MODIFICATION BULLETIN

AIRPL
MODEL
91
Safir

91. 6/3

Engine cowling. Introduction of a leather cuff

VIEW A

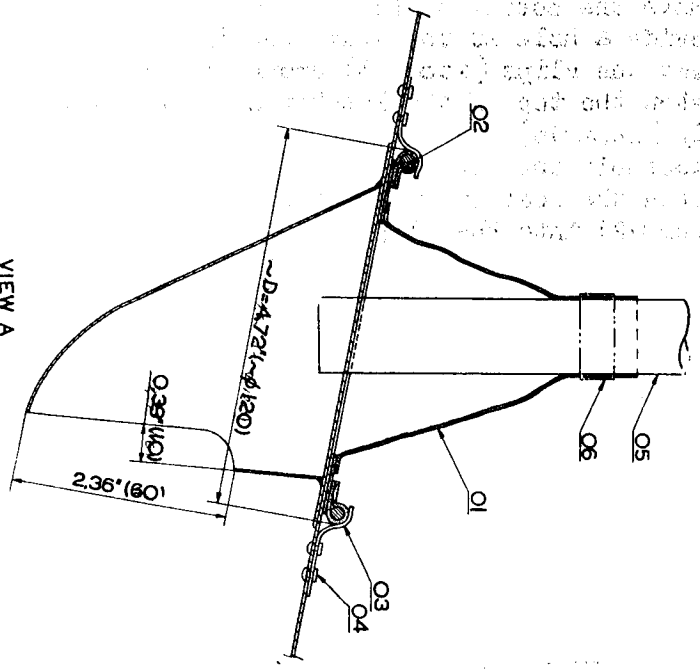
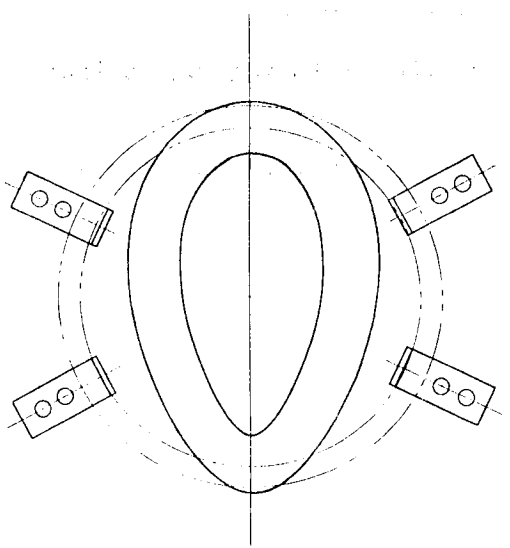
The oil consumption of the engine in some cases has been abnormally high. Furthermore there has been leakage at the propeller shaft. The cause of this has been that the overpressure in the crankcase has been too great.

By introduction of a leather cuff acting as a sealing between the engine vent line and the bottom plate of the cowling the oil consumption will be reduced and the leakage at the propeller shaft will stop.

Remove the bottom plate

Provide a hole at the drain cap in the bottom plate, see figure.

Rivet the clips (item 03) around the hole.

Fasten the top of the leather cuff to the vent pipe (item 05) using the existing clip (item 06).

Reassemble the bottom plate

Fasten the leather cuff (item 01) to the bottom plate by pressing the wire spiral (item 02) into the clips.
